3-5 DANFORTH STREET

Permit to construct a 45' x 33' addition on the left side of existing restaurant as per plans is being issued herewith subject to the following Building Code requirements:

Subject: Building permit for alterations in the
restaurant at 1-3 Danforth Street

Subject: Building Permit for Alterations in
Apartment House owned by William H. Morris
at 3 Danforth St.-NHA E-17-1A-5

SKETCH OF BLDG.
SHOWING SIGN
LOCATION.
3 1/2 STORY
WOOD + BRICK

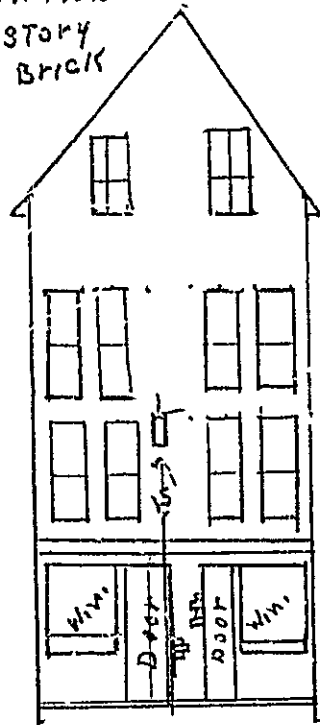
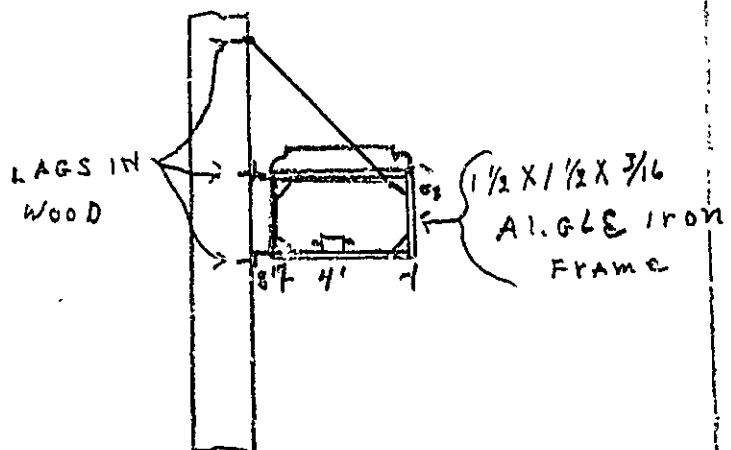
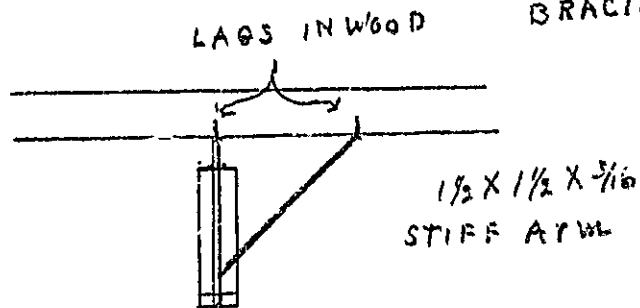
In accordance with my circular letter to erectors of signs projecting over public sidewalks or streets of October 20, 1937, it will be necessary for you to furnish the plans in duplicate for the sign proposed for Watson's Cafe at 3 Danforth Street.

It will be necessary for us to have the plans in duplicate before the permit may be issued. The sketches are perhaps to scale, but no definite scale is marked upon them.

May I suggest that you get your sketches in a smaller compass. For instance, no reason appears why all of the information for this sign at 3 Danforth Street could not be placed upon one letter size sheet of paper and without using the reverse side without leaving out any of the necessary information.
